INITIAL SITE REPORT
VERNON COUNTY LANDFILL
(WIDNR LICENSE NO.3268)

B-6 – WDNR Vernon County ISR Opinion February 15, 2022

Subject: Initial Site Report Opinion Letter for the Proposed Vertical and Horizontal Expansion
Vernon County Landfill, Vernon County, Wisconsin, License #3268

Subject: Acceptance of Proposed Alternative Geotechnical Investigation Program for Feasibility Study,
Vernon County Landfill, Vernon County, Wisconsin – License #3268

10 North Bridge Street Chippewa Falls, WI 54729 PHONE: (715) 720-6200 FAX: (715) 720-6300 WATTS: 800-472-5881 www.sehinc.com	PROJECT: VERSW157634	ISI REQUEST VERNON COUNTY LANDFILL (WIDNR LICENSE NO.3268)		Distance to Viroqua Municipal Airport	Figure 1
	DATE: 10/20/2020

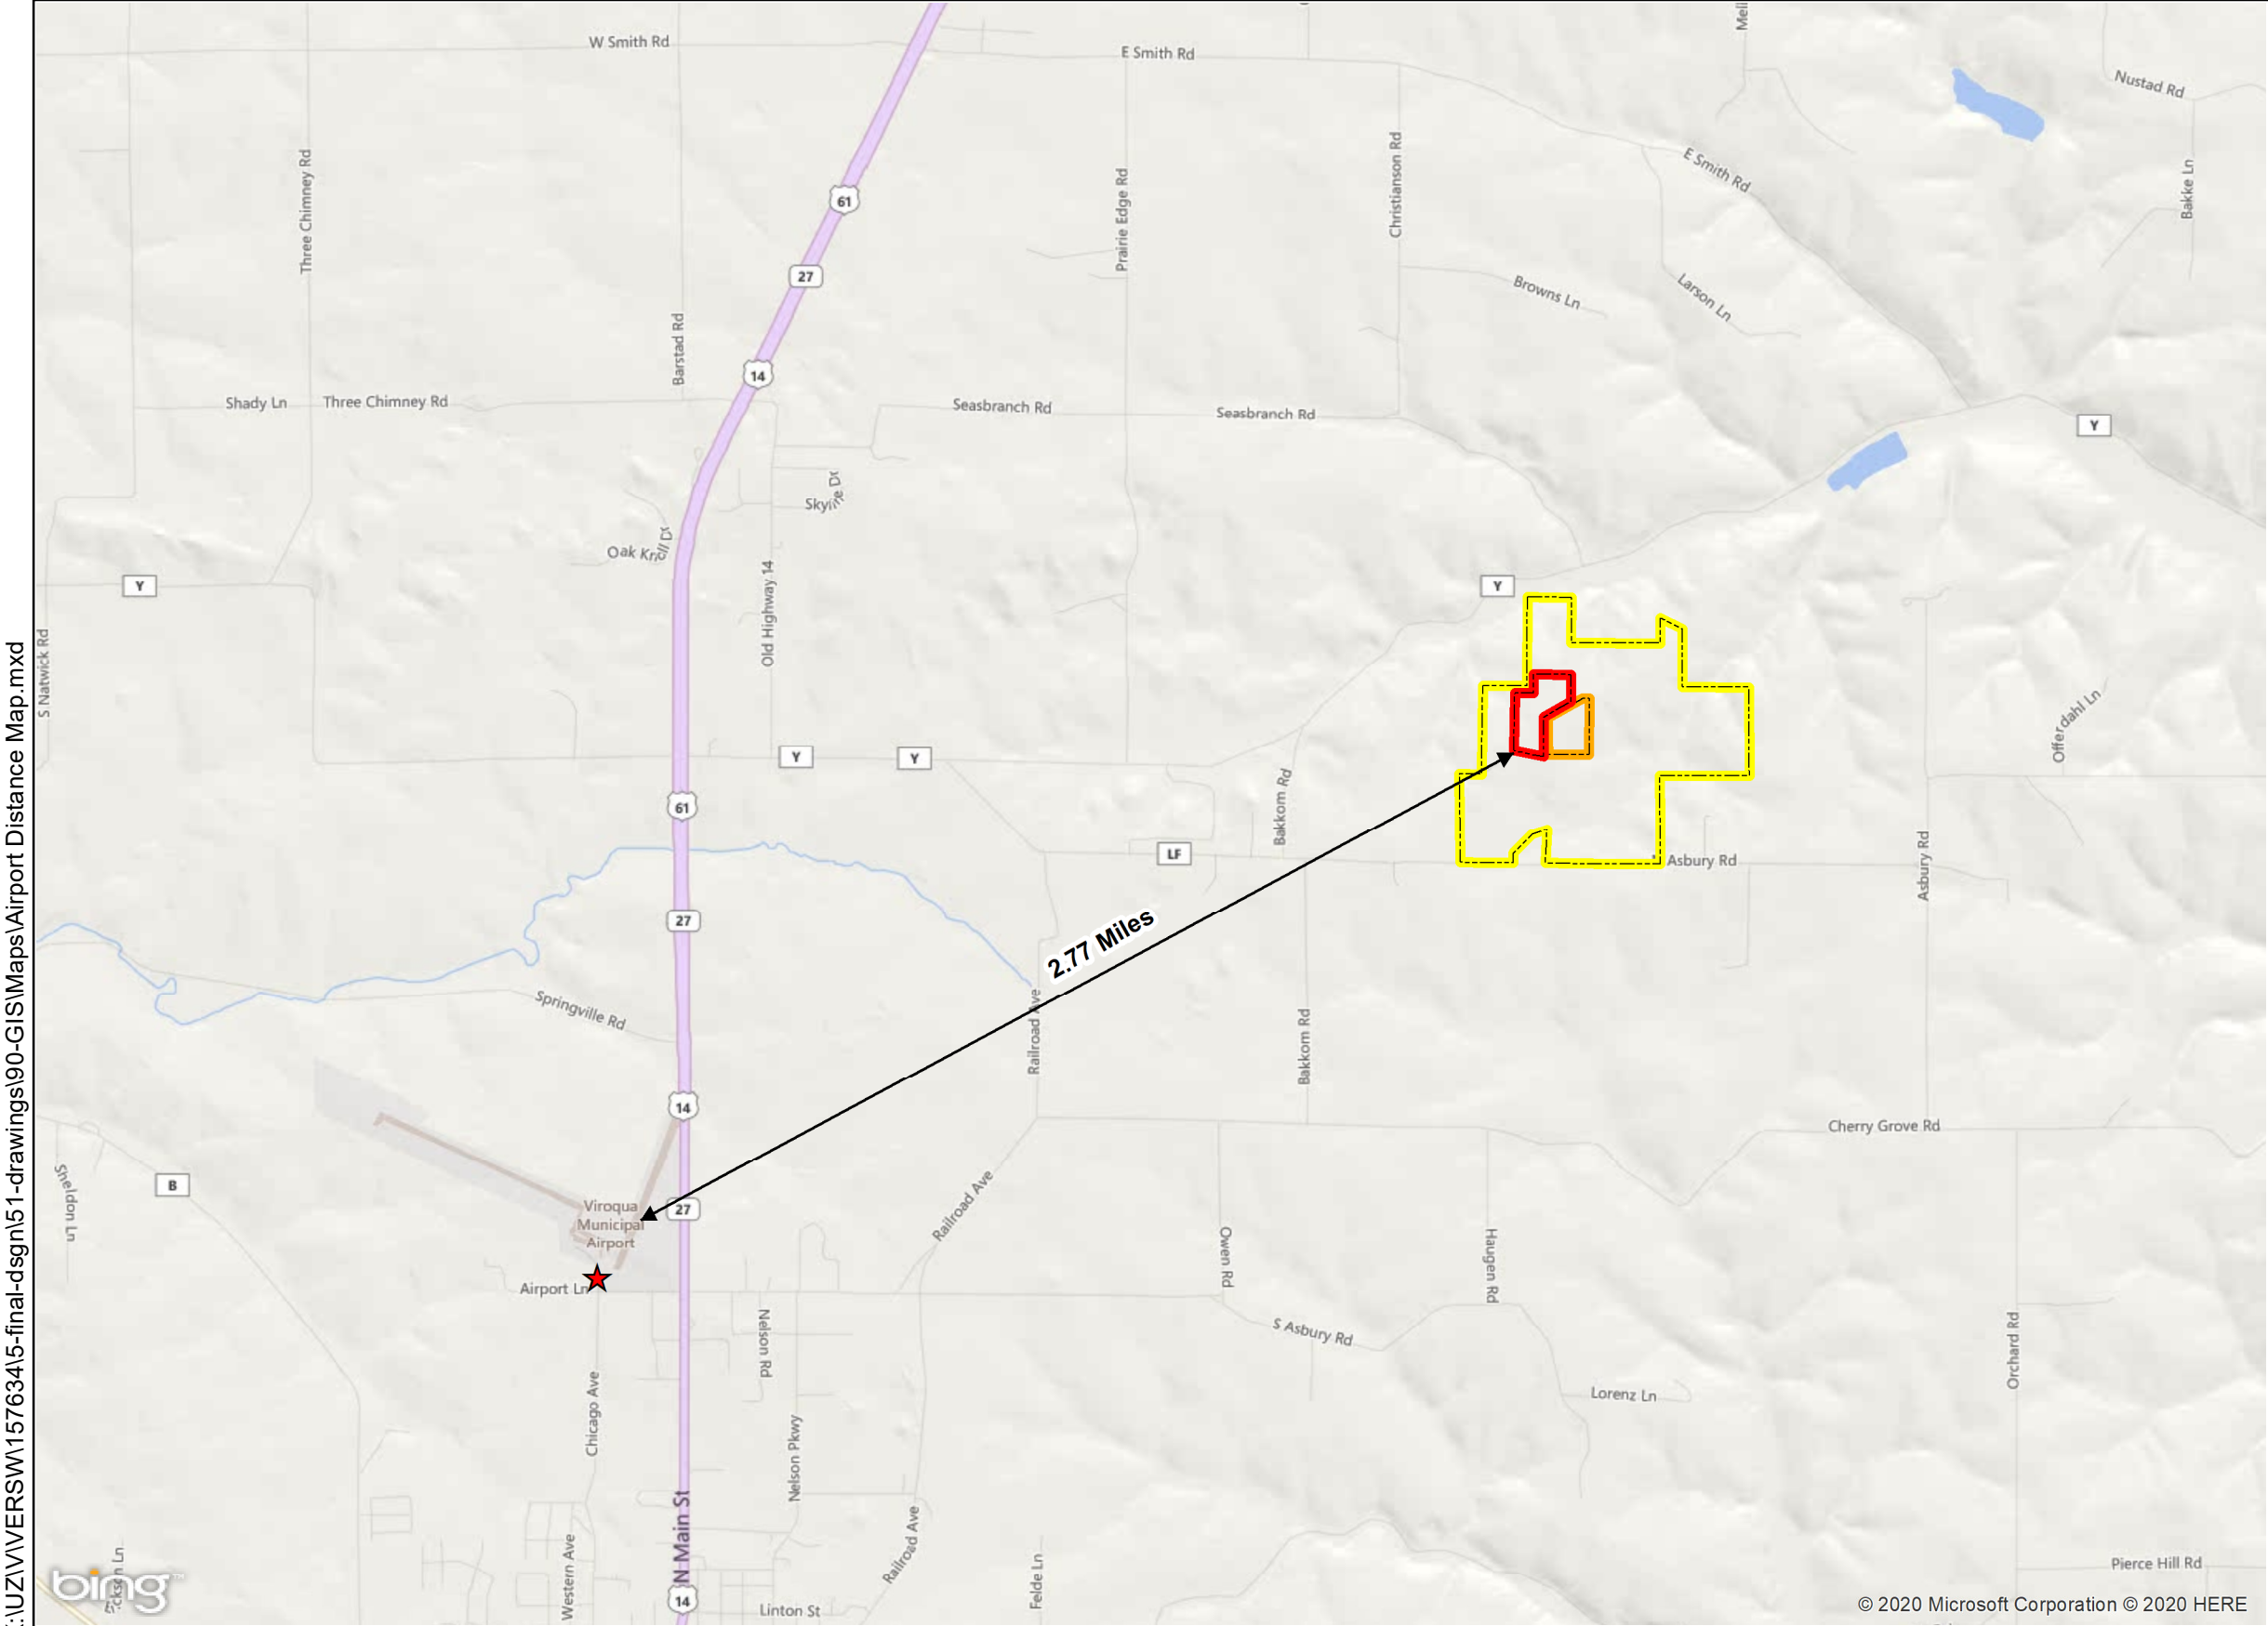
The proposed Vernon County Landfill Expansion (Landfill Expansion) is located in the Southern Half of Section 12, T13N, R4W, Town of Viroqua, Vernon County, Wisconsin. The proposed horizontal landfill expansion encompasses approximately 10-acres due west and north and contiguous to the current permitted landfill. As shown the Attached Figure 1, "Site Location" the landfill expansion is located approximately 2.8 miles northeast of the closest runway at the Viroqua Municipal Airport and the existing landfill and expansion are not located in the approach or departure path for the airport.

We concur with your conclusion that the provisions of 49 USC 44718(d) do not apply to this proposed expansion of the Vernon County Landfill. These provisions specifically do not apply to landfills that were constructed or in operation prior to April 5, 2000. The Vernon County Landfill was first constructed in 1993. In addition, the Viroqua Airport does not have regularly scheduled service in addition to general aviation operations, so the provisions of FAA AC 150/5200-34A, Construction or Establishment of Landfills Near Public Airports do also not apply.

Regarding the provisions of FAA Advisory Circular No 150/5200-33B, Hazardous Wildlife Attractants On Or Near Airports: The Landfill is outside the 10,000' area of primary concern identified in the AC. While FAA encourages the Landfill to continue its efforts under their Wildlife Hazard Management Plan, we recognize that FAA does not have regulatory or approval authority over the Landfill in this regard.

Based on the above, FAA has no objection to the proposed expansion at the Vernon County Landfill. Please feel free to contact me if you have any questions or additional concerns.
